CITY OF TAYLOR, TEXAS PLANNING AND ZONING COMMISSION MEETING September 14, 2021, 6:00 P.M.

Staff has completed its review of plans for the RCR-Taylor Logistics Park Preliminary Plat, located at the southeast corner of US 79 and FM 3349, Taylor, TX 76574. There are some corrections that need to be made prior to recordation of the plat. Comments from this review follow.

Staff has completed its review of plans for the RCR-Taylor Logistics Park, Phase 1, Amending Plat, located at 201 FM 3349, Taylor, TX 76574. There are some corrections that need to be made prior to recordation of the plat. Comments from this review follow.

Staff has completed its review of plans for the Stellata Business Subdivision Minor Plat that is to be located at FM 397 & Mallard Ln. There are some corrections that need to be made prior to recordation of the plat. Comments from this review follow.

RCR-TAYLOR LOGISTICS PARK PHASE 1, LOT 1A, AMENDING PLAT

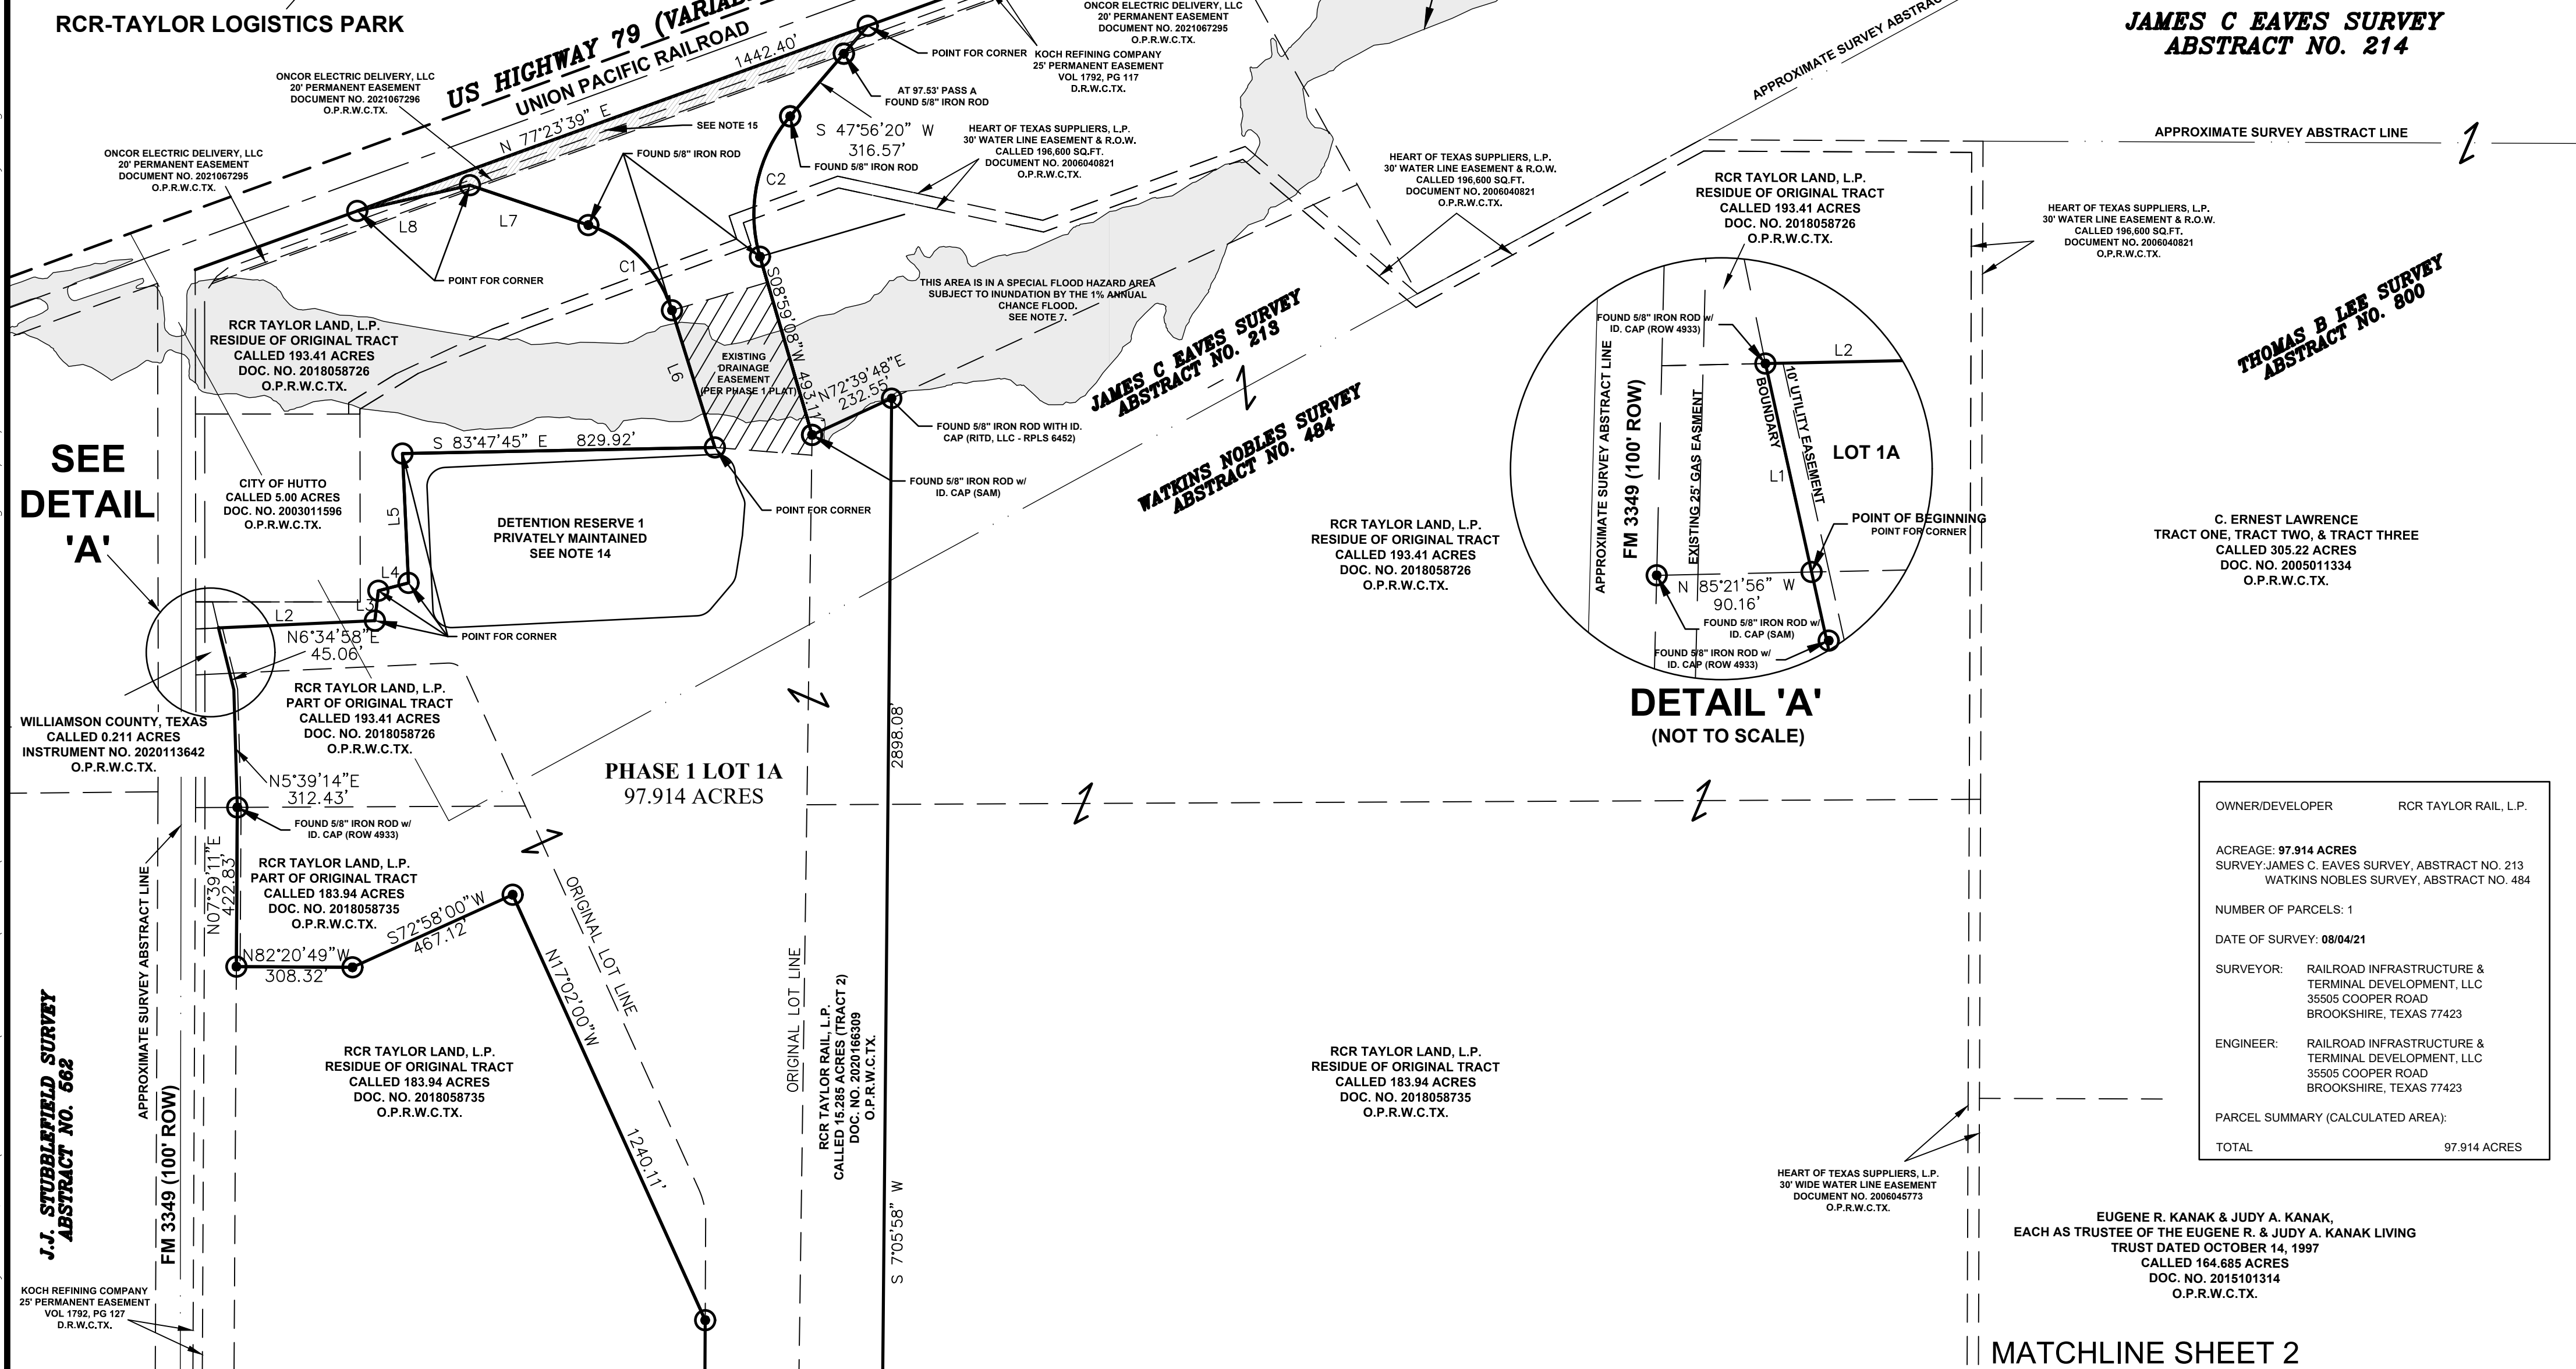
1. The Title and Description are supposed to be in the middle at the top of each sheet.

2. Make Phase 1 like a water mark within the lot but not next to "Lot 1" and replace it with "Block 1".
3. The word "easement" is misspelled in Detail "A"

4. Correct all the deed recording numbers in the Owner's Certificate. Make sure the Title in the Owner's Certificate matches the Title on the plat. Add an "s" to the word "deed" and remove the word "a" right before the word "deed".

5. Make corrections to Notes 9, 13 and 14. The alignment is bad on 9, 13 states all structures have to be 2 feet above the Floodplain but I remember it being the structures in the Floodplain only and 14 remove the number "5" after the word "under".

6. See the Planning mark ups uploaded in the Review Files.
7. On the prelim a 80-foot wide access easement is shown but it was not shown on this plat and needs to be established by plat now. Also, there is a 50-foot wide private access easement shown in the Detail B where the 50-foot vegetative buffer is supposed to be.

9. Per the Planned Development the 50-foot vegetative buffer is to be located adjacent to all roadways and ROWs.
10. Part of the land that is being added to the new Lot 1A is not owned by RCR Taylor Rail LP. The listed owner in the Owner's Certificate so it needs to be corrected.

11. Show the Koch Easement by the Naivar's property the same way you did on the original plat.
12. Below are the R #s. You are using old ones. The info you provided says there are 2 lots. If you can correct any of the incorrect information in the application do it b/c we cannot correct your mistakes.

17. Correct Note 13 as buildings in the floodplain have to be 2-feet above the BFE.

19. Label the 50-foot vegetative buffer. Provide a note in the General Notes.

1. Provide a tie to the original abstract survey.
2. Comments from other departments shall be corrected/revised.

Plat note #11 shall reflect the correct International Fire Code section that covers fire suppressions systems and fire hydrants.
